Document Number: <u>CY-OC-170-301</u>		Revision: <u>2</u>	
Title: <u>Offsite Dose Calculation Manual for Oyster Creek Generating Station</u>			
<input type="checkbox"/> New	<input type="checkbox"/> Cancel Document	<input type="checkbox"/> Cancel Revision	<input checked="" type="checkbox"/> Revision
EC#: _____		PCR#: _____	PPIS#: _____
<input type="checkbox"/> Editorial		ER#: _____	AR#: _____
<input type="checkbox"/> Batch		#: <u>567226-09-11</u>	
<input type="checkbox"/> Supersede corporate document(s) List: <u>None</u>			
Revision Summary: <u>Attachment 1 of ODCM Summary Matrix (CY-AA-170-3100) has changes</u>			
Attach add'l descript, if req'd			
Impact on Operating and Design Margins: <input checked="" type="checkbox"/> N/A			
Attach add'l descript, if req'd			
CONFIRM that no commitments (i.e., those steps annotated with CM-X) have been changed or deleted unless evaluated via completion of LS-AA-110 commitment change/deletion form and INITIAL [Preparer]: <u>RA</u>

Title: Offsite Dose Calculation Manual for Oyster Creek Generating Station

This activity is a revision of the Oyster Creek ODCM, procedure CY-OC-170-301. The changes are.

FIGURE D-1-2: SOLID RADWASTE PROCESSING SYSTEM

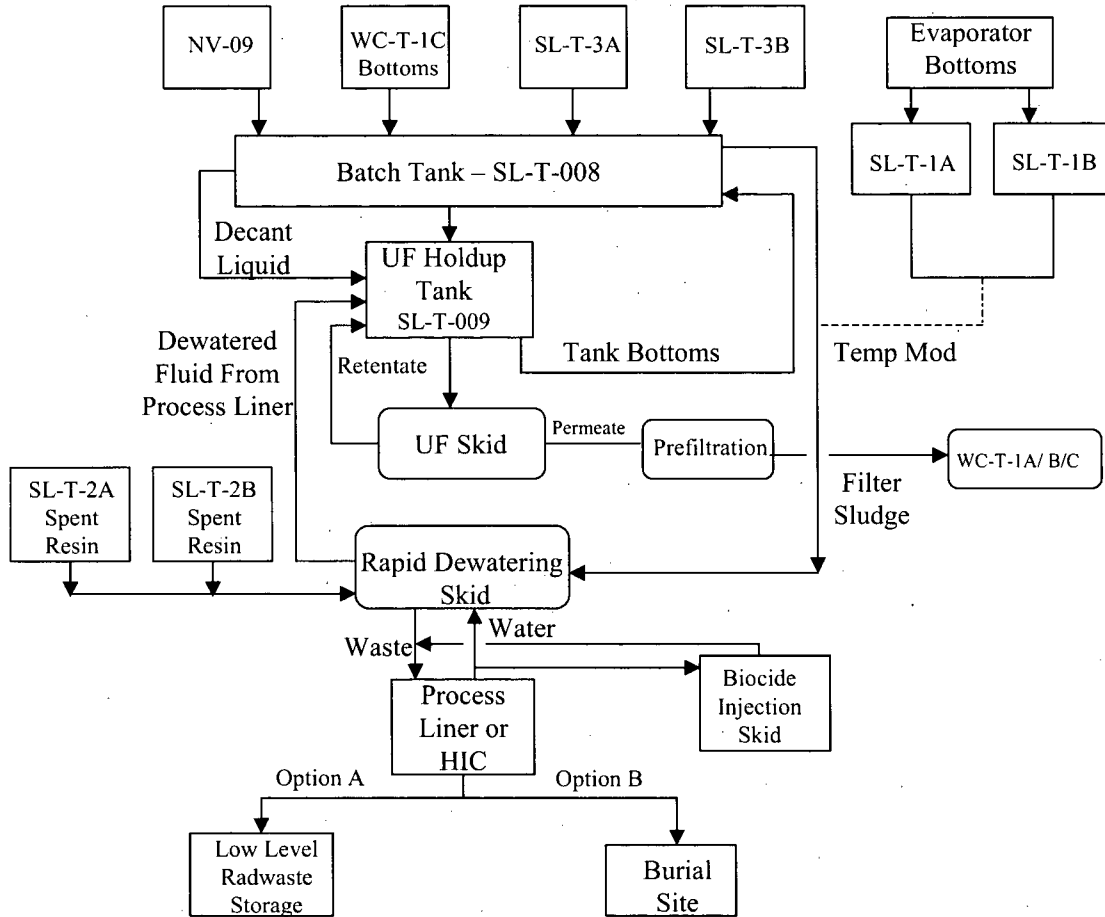
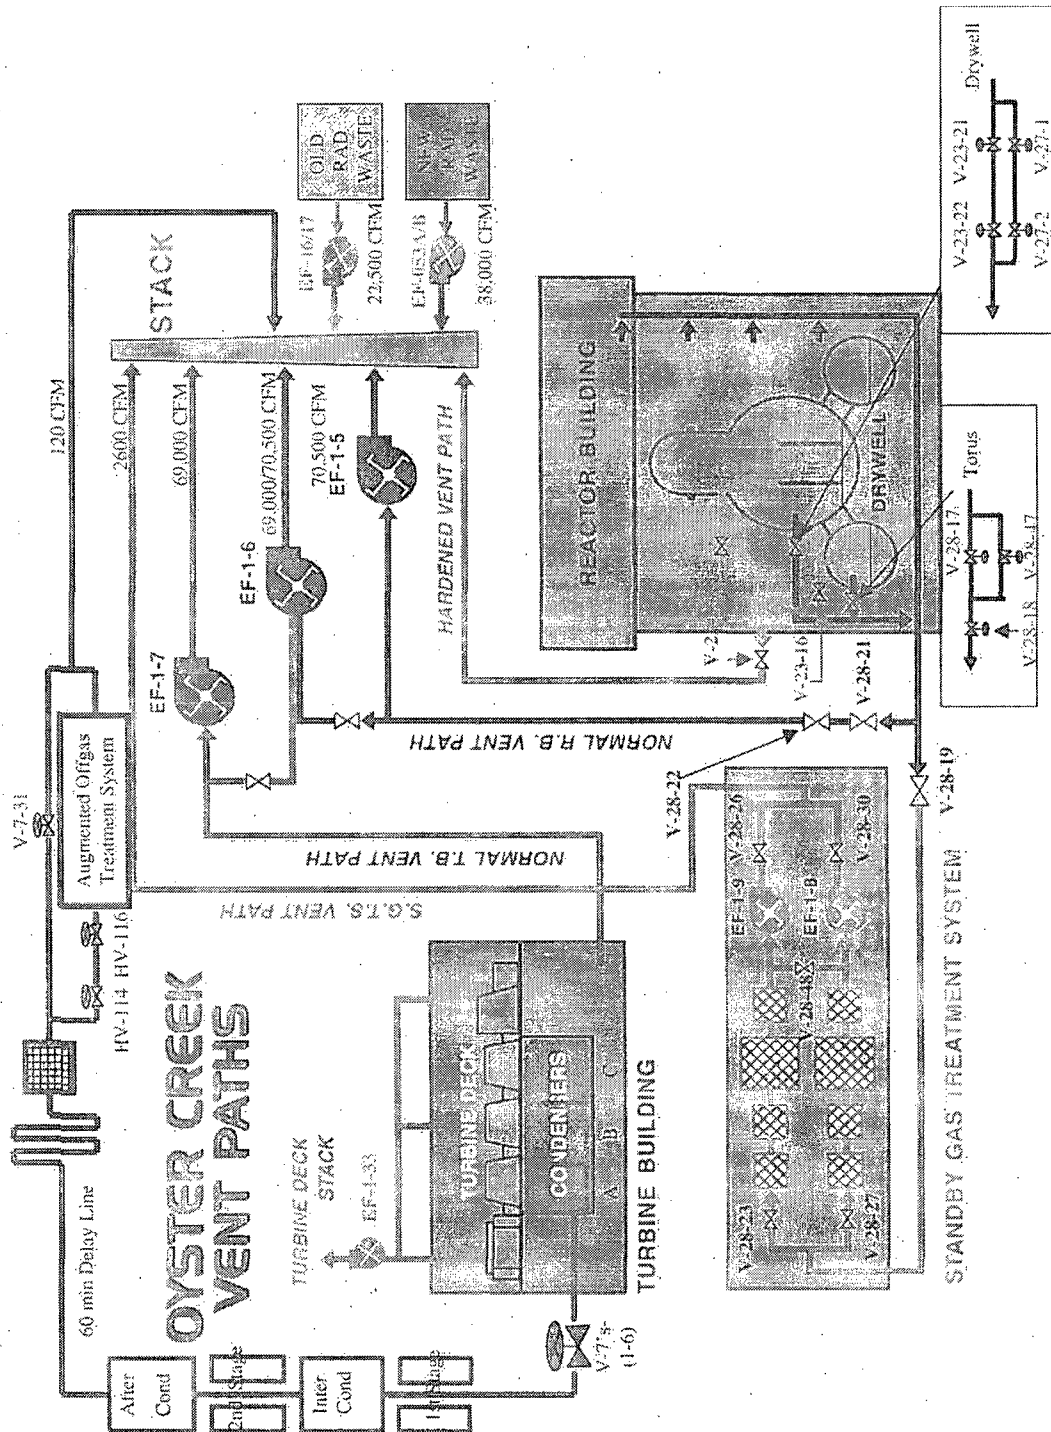
- Updated Solid Radwaste Processing System diagram, Figure D-1-2. Added tanks to drawing.

41.	108	125	A/B	Updated Solid Radwaste Processing System diagram, Figure D-1-2. Added tanks to drawing.
42.	53	60	A/B	Added the words "elevated release" prior "D/Q" in the last paragraph on the page.
